PROJECT ADDENDUM:

File No. MD23-026-085(H)
Exhibit W
Date 7.16.24
Initials KP

ROSE GAZEBO

7407 MARKET STREET
MACKINAC ISLAND, MI

SITE PLAN

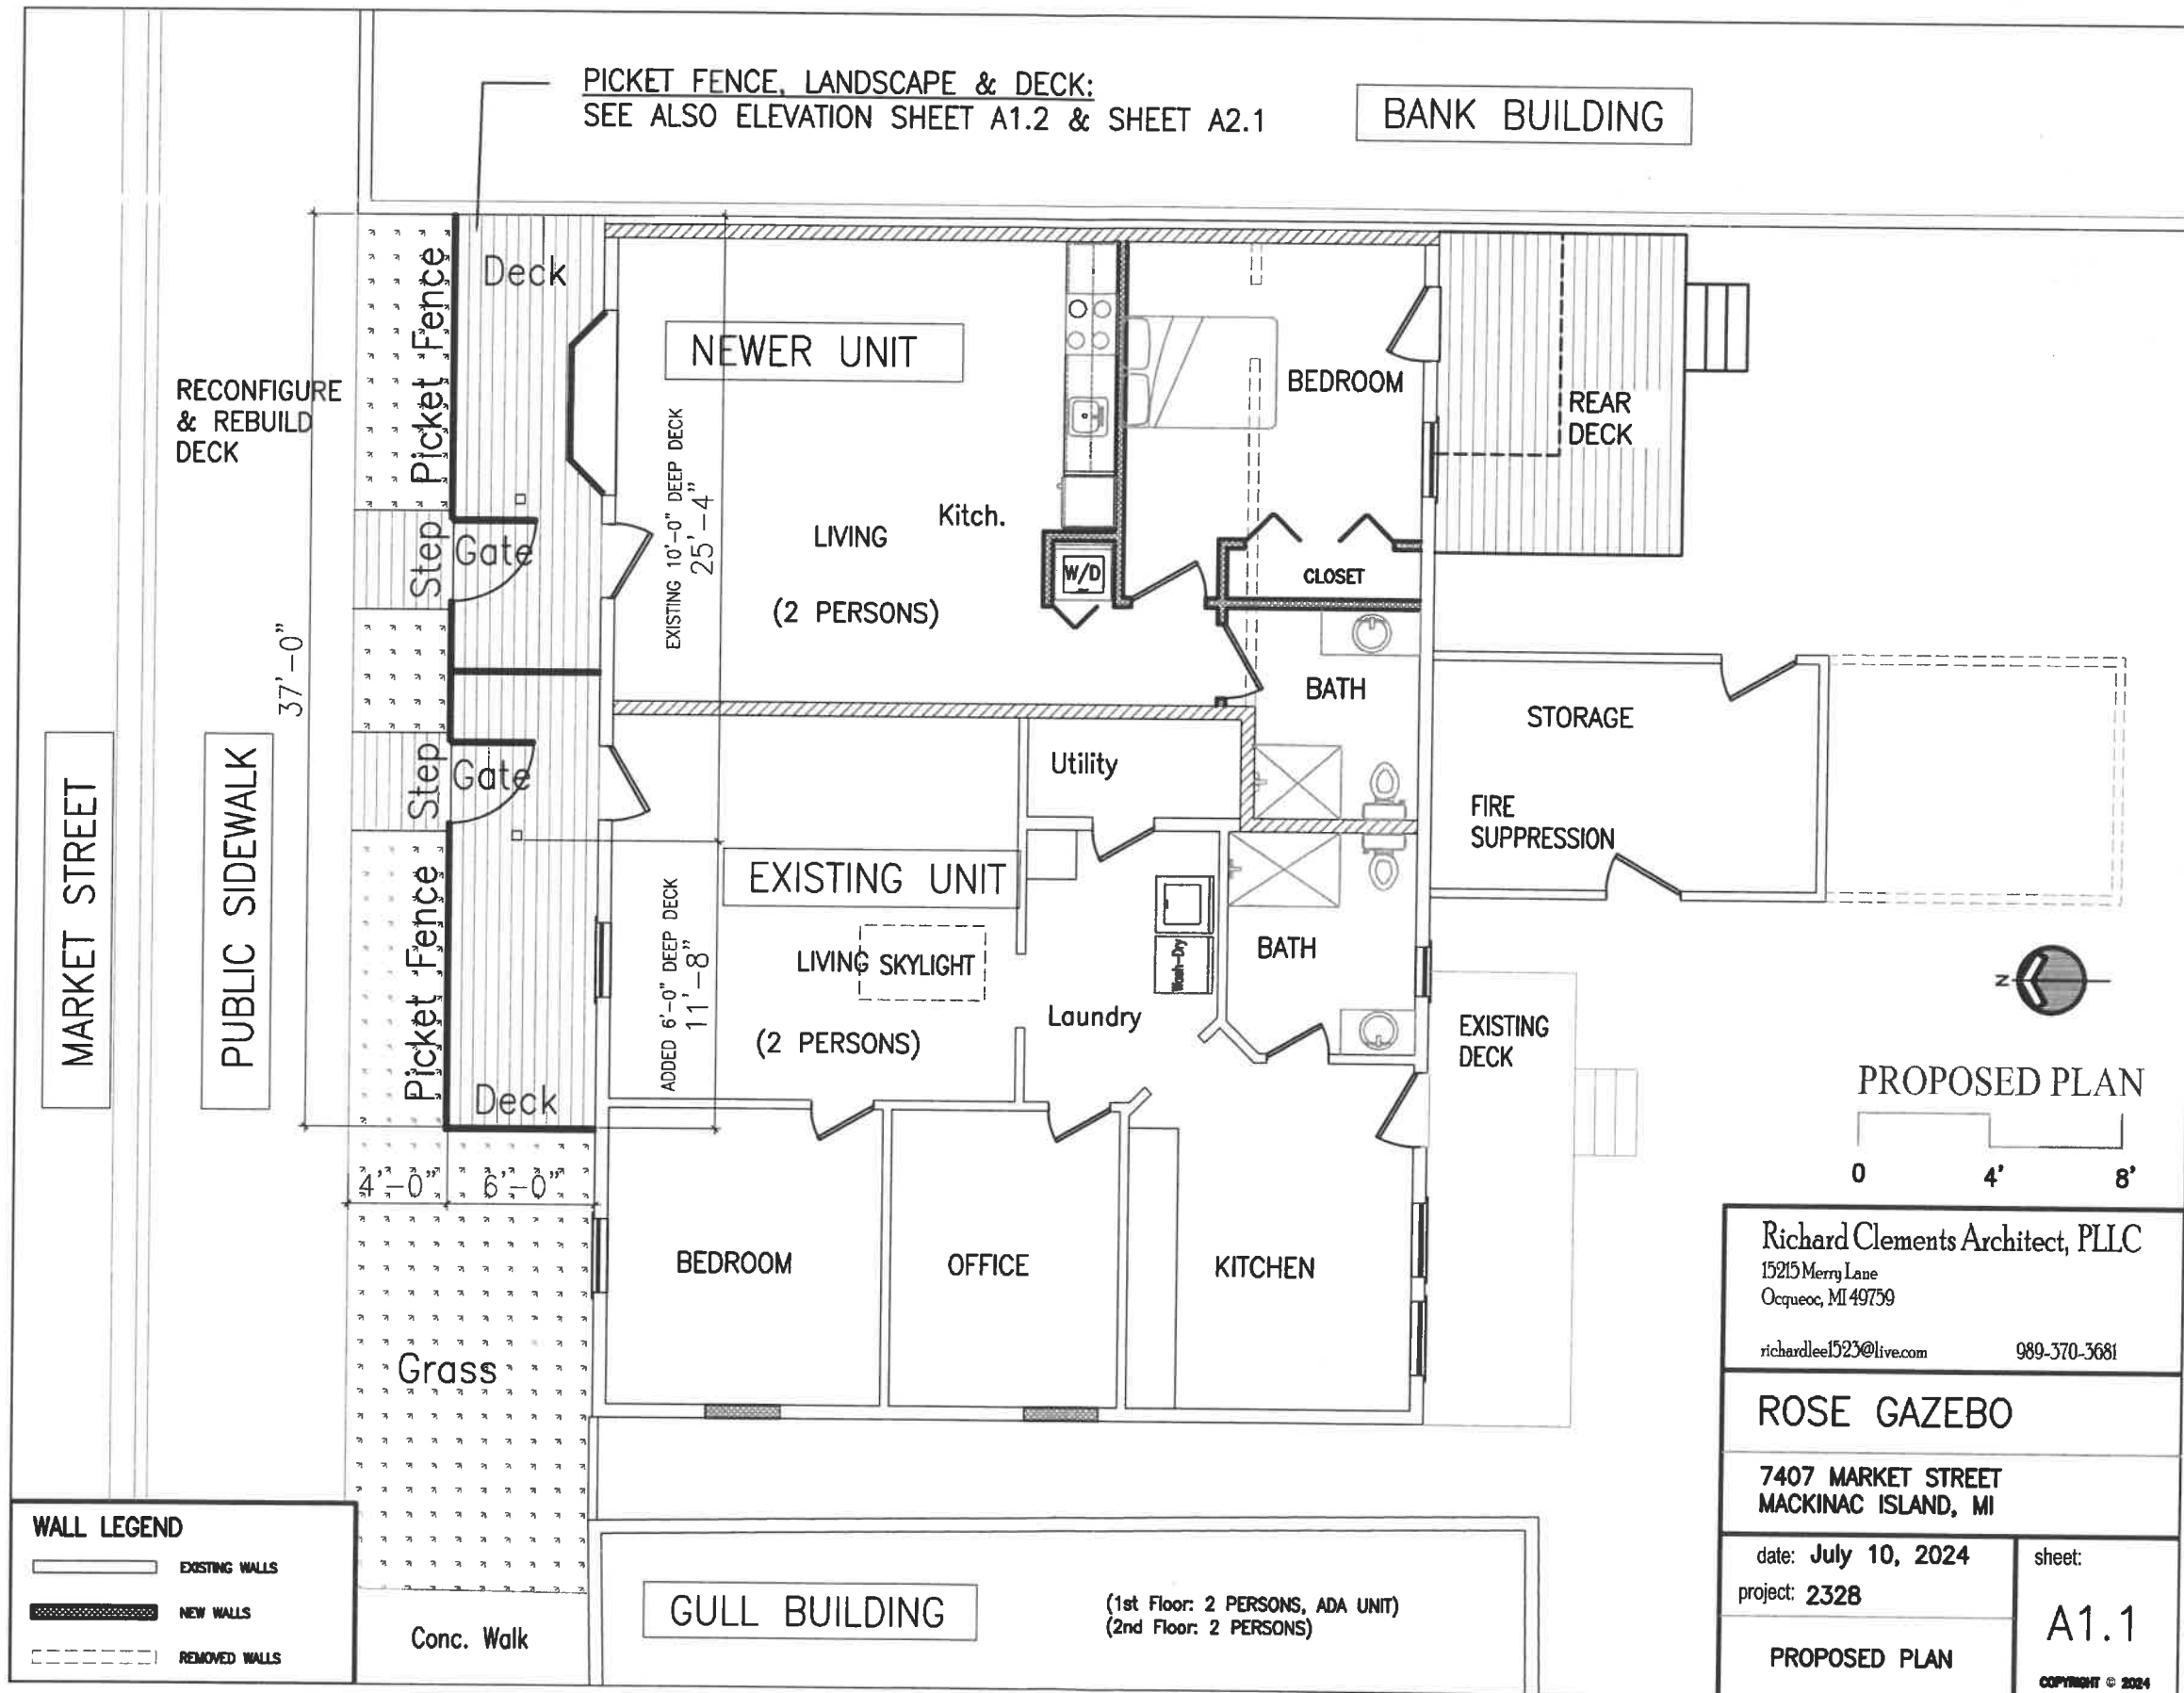
REMOVE 10' EXISTING WOOD DECK WHICH IS ADJACENT TO THE PUBLIC SIDEWALK, REPLACE
w/ 4' OF GRASS LAWN, REBUILD 6' OF EXISTING DECK w/ NEW 3"x6" TREATED DECKING.
BUILD PICKET FENCE w/ 2 GATES FOR PRIVACY AT EDGE OF DECK.

Pro. Picket Fence
SCALE" 1" = 1'-0"

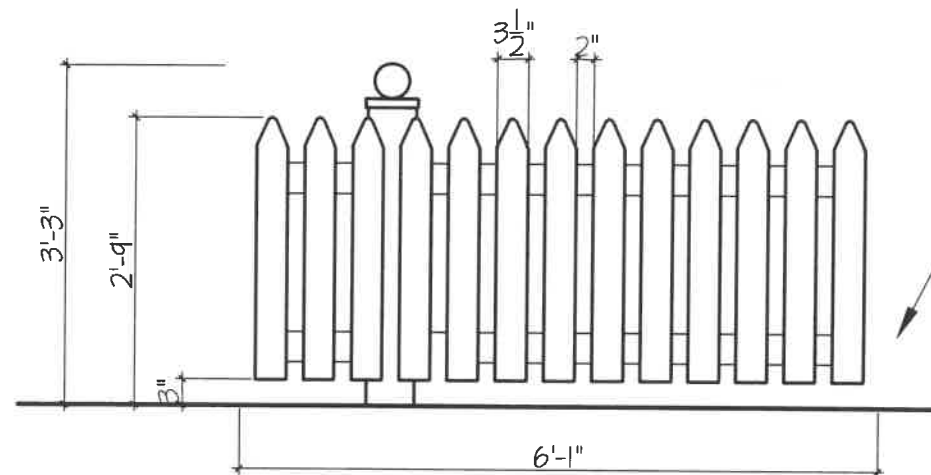
PICKET FENCE CONSTRUCTION:
1x4 CEDAR PICKETS w/ 2" SPACING PAINTED WHITE
4x6 CEDAR POSTS PAINTED WHITE
